and Management Parameters for 10 Mb/s Operation and Associated Power Delivery over a Single Balance

Cl **147** SC **147.9.2** P **203** L **32** # **i-1**

[6] Insert a new Figure 145-6 shown below (view using a non-proportional font such as courier), renumbering the following figures as required.

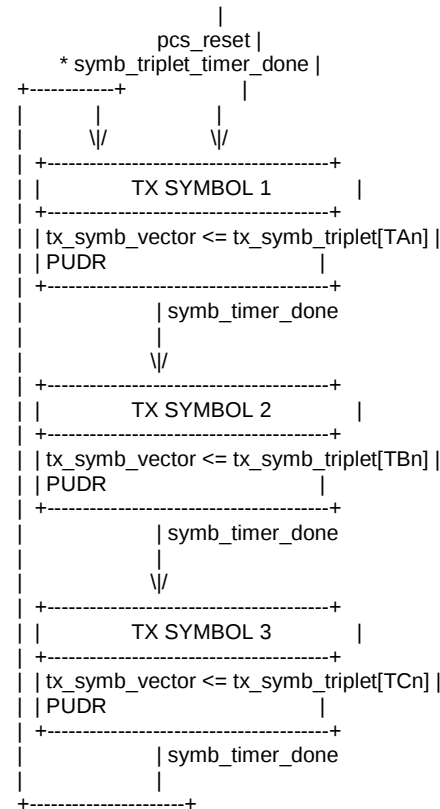
Is it correct that 'The PCS Transmit function shall conform to the PCS Transmit state diagram in Figure 146-5 ...' and that 'In each symbol period, PCS Transmit generates a symbol An provided to the PMA ...'? The PCS Transmit state diagram in Figure 146-5 changes state based on STD being true, with STD being an alias for symb_triplet_timer_done, and the output of the PCS Transmit state diagram is tx_symb_triplet which is defined in subclause 146.3.3.1.1 'Variables' as 'A triplet of ternary symbols generated by the PCS Transmit function after 4B3T encoding.'

I think the problem is that there is another function within the PCS Transmit function that is missing from the PCS Transmit state diagram in Figure 146-5, the 'multiplexor' shown in Figure 146-6 'PCS transmit symbol generation'. This 'multiplexor' function operates at the symbol clock rate and serialises the tx_symb_triplet code-groups output by the PCS Transmit state diagram into individual symbols.

This may also explain when subclause 146.3.3.1.3 'Timers' defines the symb_timer that is not used in the PCS Transmit state diagram in Figure 146-5.

[4] Add a new subclause 146.3.3.2.2 titled 'Timers'. Move the symb_timer definition from subclause 146.3.3.1.3 Timers to this new subclause.

[5] Add a new subclause 146.3.3.2.4 'Abbreviations' that reads:

[7] Add text to subclause 146.3.3 'PCS Transmit' that reads 'The PCS Transmit function shall conform to the PCS Transmit state diagram in in Figure 146-5 and the PCS Transmit multiplexor state diagram in 146-6, and their associated state variables, functions, timers, and messages.'
